September 29, 2020

**Re: Applicant's Response to ANC Resolution
Z.C. Case No. 20-14 - Design Review
5 M Street, SW (Square 649, Lots 43, 44, 45, and 48)**

Figure 1

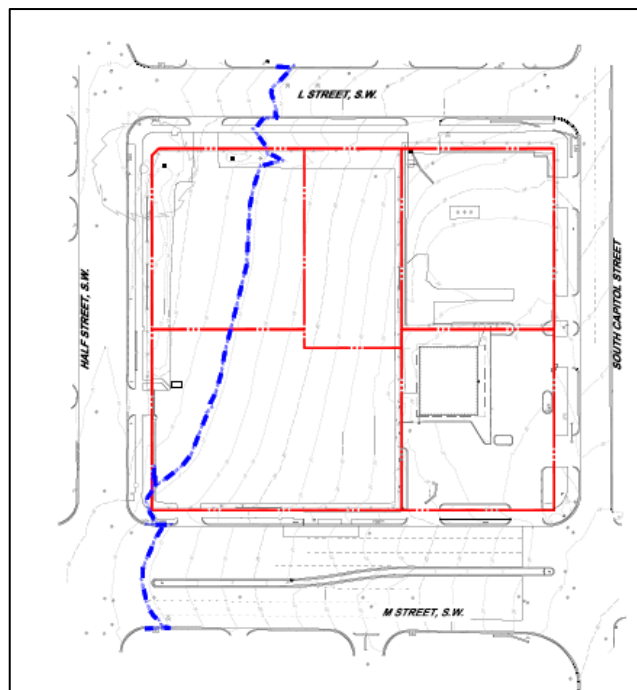
With respect to flood resiliency, a small portion of the Property is located within the 500 year floodplain (*see Figure 1*). Accordingly, the Applicant has been working with DOEE to ensure that the building is fully compliant with current regulations required for projects within the 500 year flood plain and consistent with DOEE's strict guidelines and strategies for flood plain management. Moreover, the building has been designed so that the residential slab is elevated above the 500-year floodplain elevation.

Consistent with this policy, and as described above, Applicant has designed the building so that the residential slab is elevated above the 500 year flood plain, and has incorporated a variety stormwater management strategies.
